Appendix B

Field Work Variances

FIELD WORK VARIANCE

Project Name/Number	Fort Ord / 846075	CTO/WAD	CTO 16 / WAD 06
Applicable Document:	Draft Final Work Plan, MRS-16		Date: 12/27/06
Munitions and Explosives of Concern Removal, Former Fort Ord, California, August 2006, Revision 1

FIGURE 1
MRS 16 BOWL GRIDS
 - FT. ORD, CA -

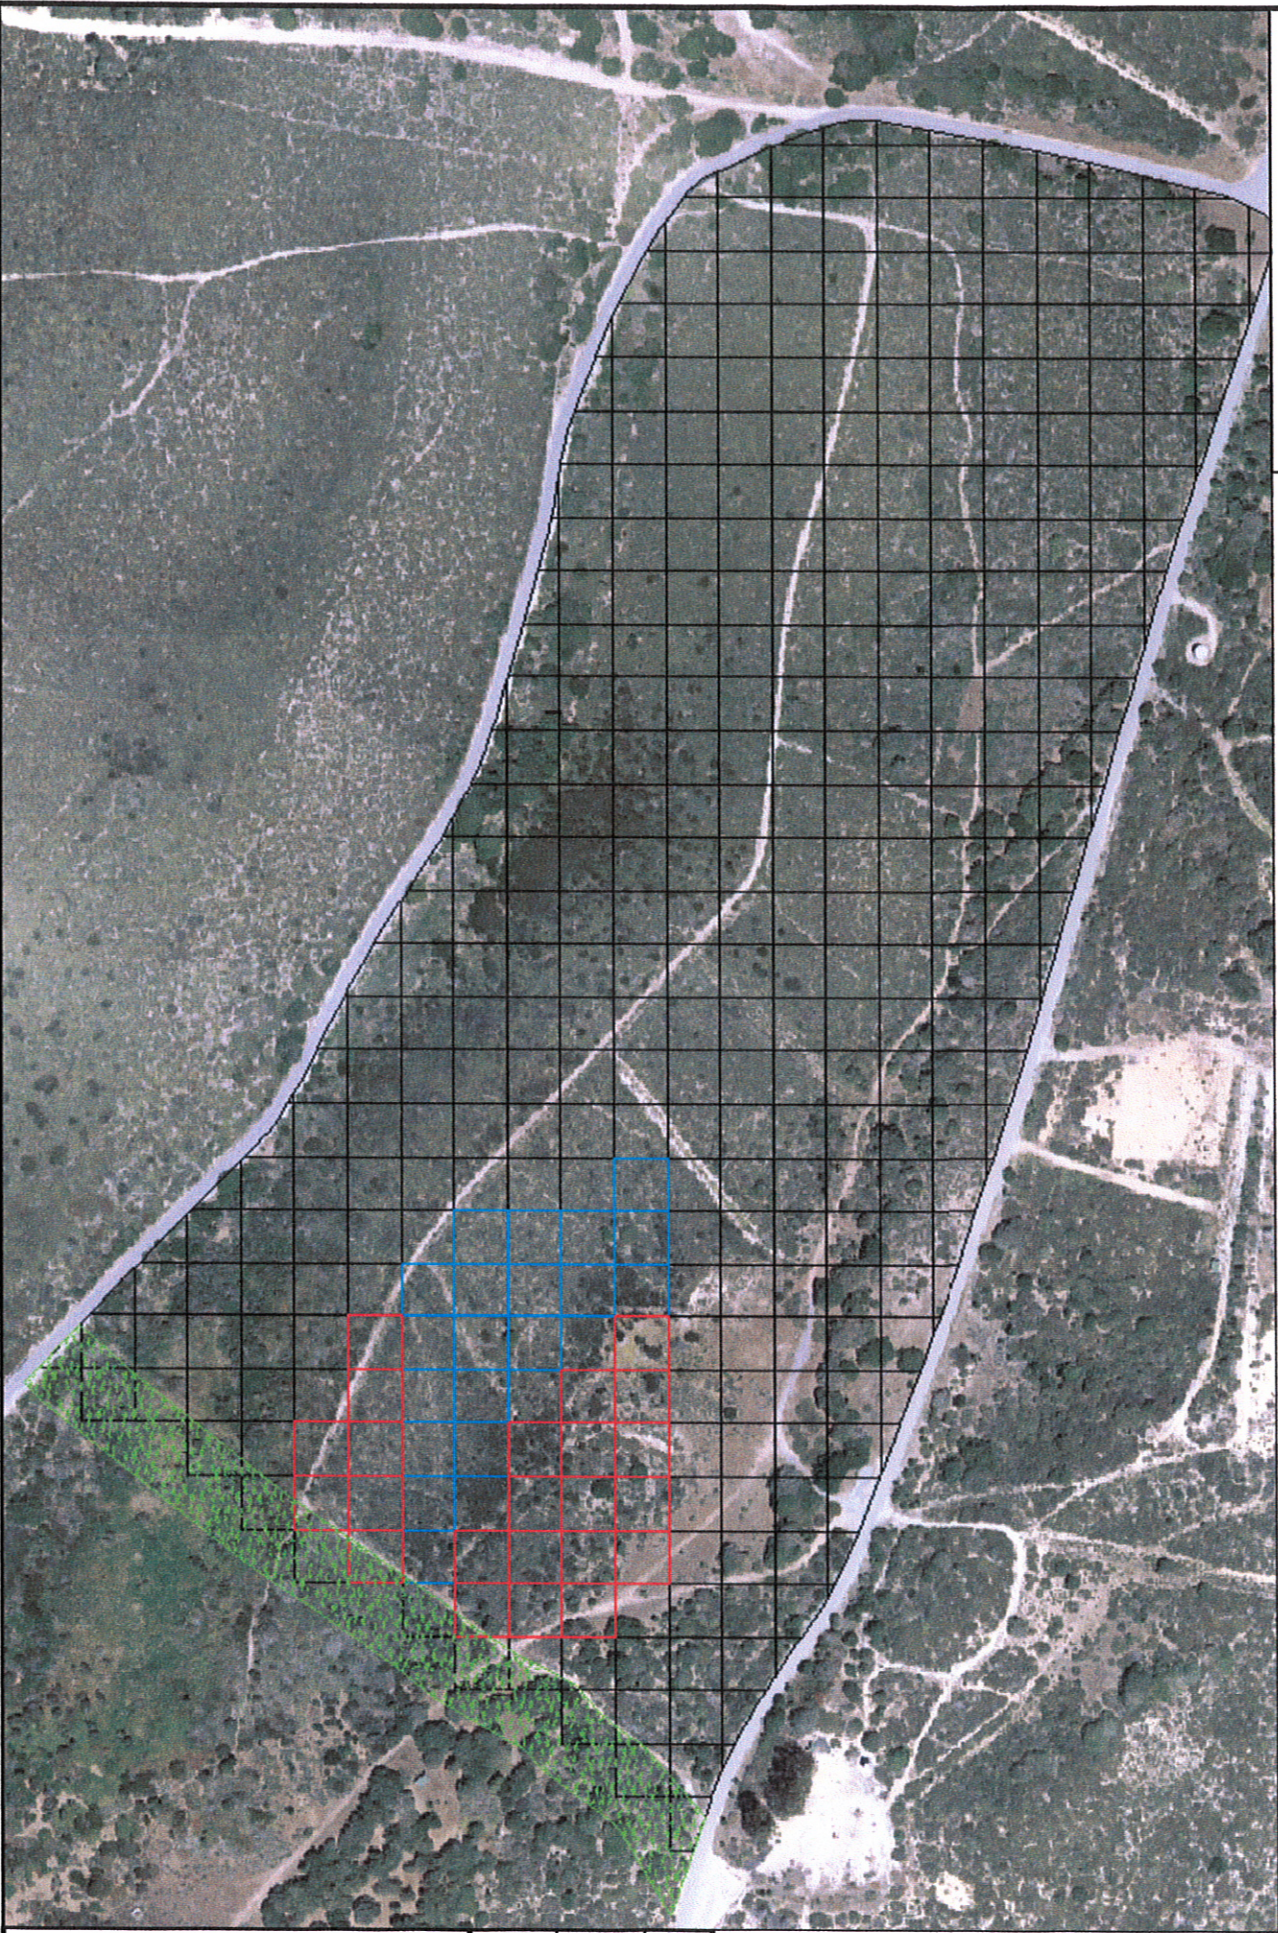
Recommended revisions to the plan: Conduct magnetometer assisted surface and subsurface removal in 23 grids (See Attachment 1) within the approximately 13.5 acres prior to DGM implementation. Subsurface removal may allow for better mapping of distinct anomalies during initial DGM phase.
